Section 2.1 MetroLink Building Damage Assessment of Cadenza Building

Section 2.2 MetroLink Settlement Assessment at the Cadenza Building

Section 2.4 Future Extension of the Cadenza Building

Section 2.5 Damage to the Cadenza Building Substructure in the Exclusion Zone

Section 2.1 MetroLink Building Damage Assessment of Cadenza Building

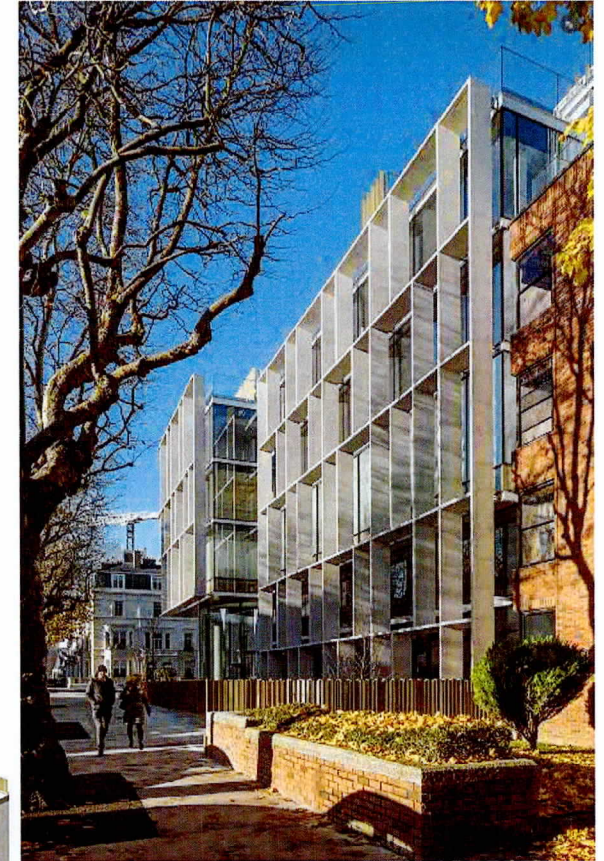
The proximity of the proposed tunnel to the existing structure has not been correctly assessed or considered by the Jacob / IDOM team. I have reviewed the Building Damage Report ("the BDR") produced by Jacob/IDOM, which was included in Appendix A5.17 of the Environmental Impact Assessment Report ("the EIAR"). In the BDR, the property referenced at the chainage of the Cadenza Building, the Davitt Building was demolished at the end of 2019, four years ago.

The Davitt Building (B147) described in the BDR is a four-story building with a 2.5m basement. It is clearly incorrect and does not represent the Cadenza Building that has been constructed.

The findings of the BDR concerning the Building Damage Categorisation are incorrect as the data used was not checked or verified.

Therefore, the expected Category of Damage present by Jacob / IDOM cannot be relied upon, which, if followed, would result in damage to our Client's building.

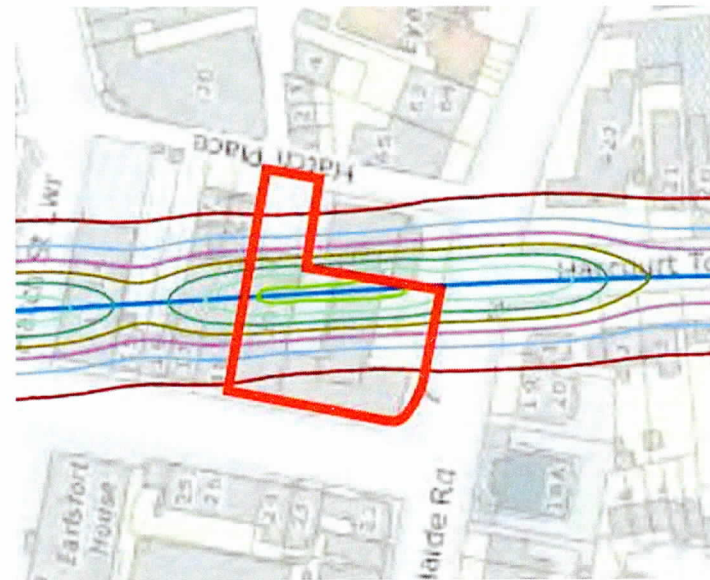
The magnitude of the subsidence/settlement under the Cadenza Building is not uniform and varies from 0mm to 30mm. The maximum subsidence/settlement is experienced directly under one of the main stair cores, which provides stability to the building.

The settlement contours presented by Jacob / IDOM indicate that differential settlement/distortion of the Cadenza Building is going to occur, resulting in the following damage:

- The basement uses a whitetank waterproofing system, which relies on the watertightness of the reinforced concrete basement floor slab and walls. Therefore, even minor cracking could lead to groundwater ingress;
- The internal reinforced concrete frame uses post-tensioned reinforced concrete floor slabs for large spans, which would be more sensitive to differential settlement than conventional RC slabs;
- The tunnel passes under one of the main structural cores for the building, and this incorporates a complex transfer structure at the first-floor level to accommodate a shift in the position of the core for the upper floors of the building;
- The building has a modern steel and glass façade, which would be more sensitive to distortion due to differential settlement along the perimeter secant pile wall than a masonry or blockwork structure.

The Cadenza Building cannot accommodate movement of this magnitude without damage to the structure, waterproofing and facades being caused.

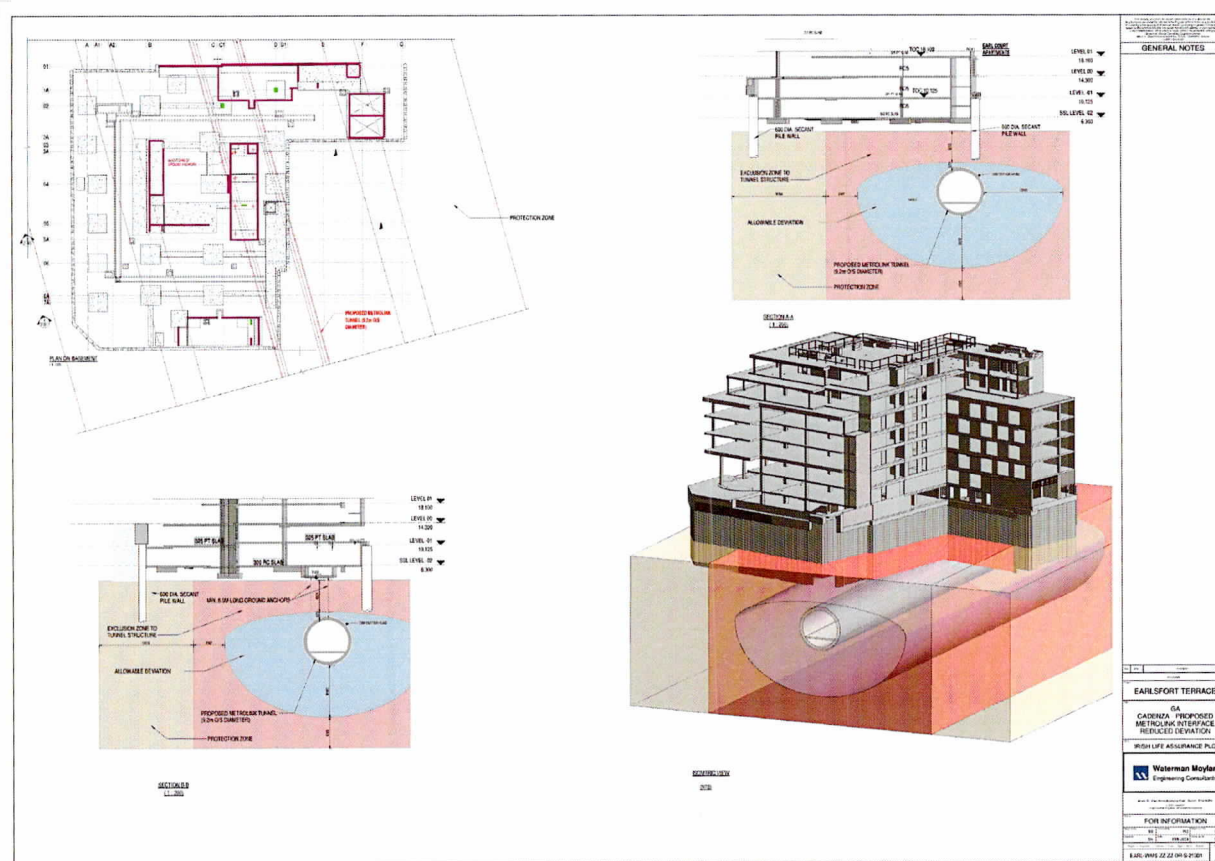
- We development drawing number EARL-WMS-ZZ-ZZ-DR-S-21301 which is included in Appendix D of our Report, which indicates the existing structure of the Cadenza Building overlaid with the proposed Metrolink tunnel route and the reduced tunnel exclusion zones set out in document DOC ML1-JAI-GEO-ROUT_XX-RP-Y-00034.

Any damage to the tension anchors or the secant piled wall is going to result in damage to the basement structure and the integrated basement waterproofing system provided through the whitetank waterproofing system.

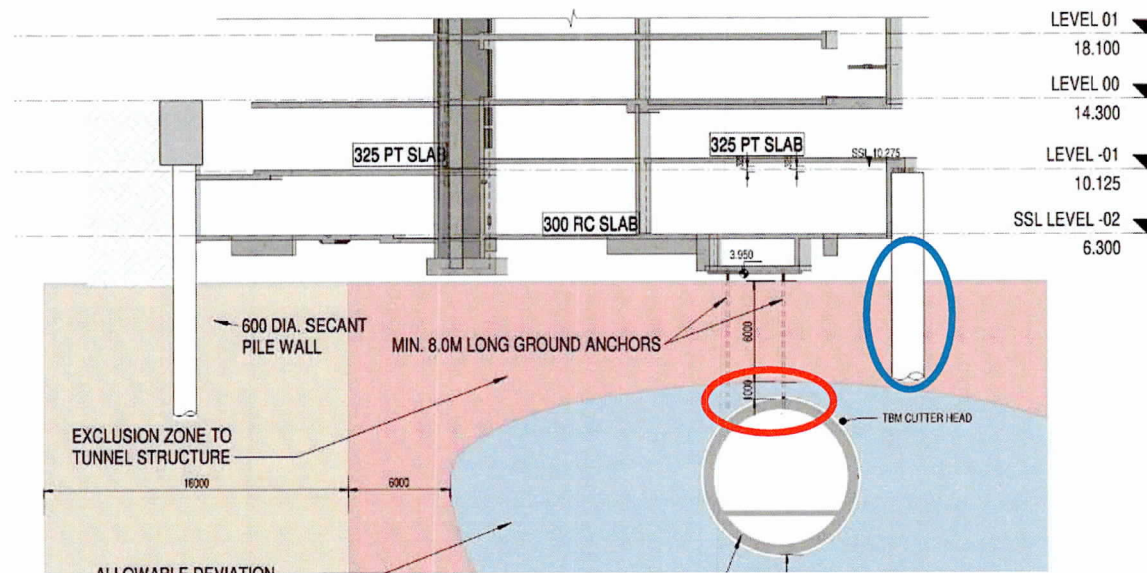
- We understand that the Cadenza Building could not have been developed in its current form had the Metrolink Tunnel been previously constructed, as there are substructure elements required to extend into the exclusion zone, which could cause damage to the Metrolink Tunnel.
- As the Metrolink Tunnel is a significant piece of infrastructure and has been designed to resist significant earth pressures, it is equally likely that such a significant piece of structure could cause damage to the existing substructure elements of the Cadenza Building that are currently in place and providing support to the Cadenza Building.

Section 2.5 Damage to the Cadenza Building Substructure in the Exclusion Zone

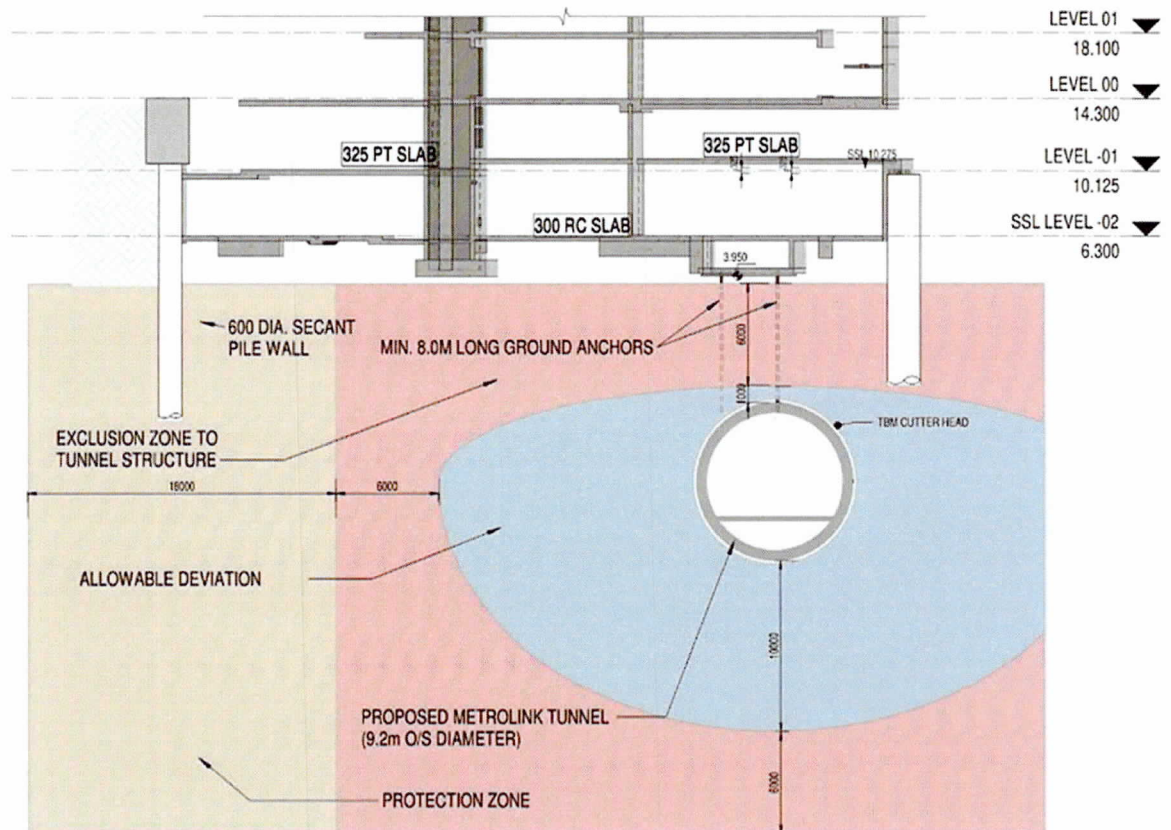
Based on our findings, we believe that if the Metrolink Tunnel is to pass under or close to the Cadenza Building, we require a detailed Phase 3 assessment using the correct building geometry and structural form to be completed and independently verified, ensuring the maximum damage caused to the Cadenza Building is limited to 0.1mm cracking.

The proposed tunnel elevation may require to be lowered more than the current LOD downwards, i.e. more than the 10.0m indicated in the Wider Effects Report submitted as part of the application, considering the proximity and sensitivity of the Cadenza Building.

Based on the findings of our Report, we believe that the Metrolink Tunnel should either be:

- 1) rerouted around the substructure of the Cadenza building or,
- 2) the elevation of the Metrolink tunnel should be significantly lowered to a level that no damage will be caused to any part of the Cadenza Building.
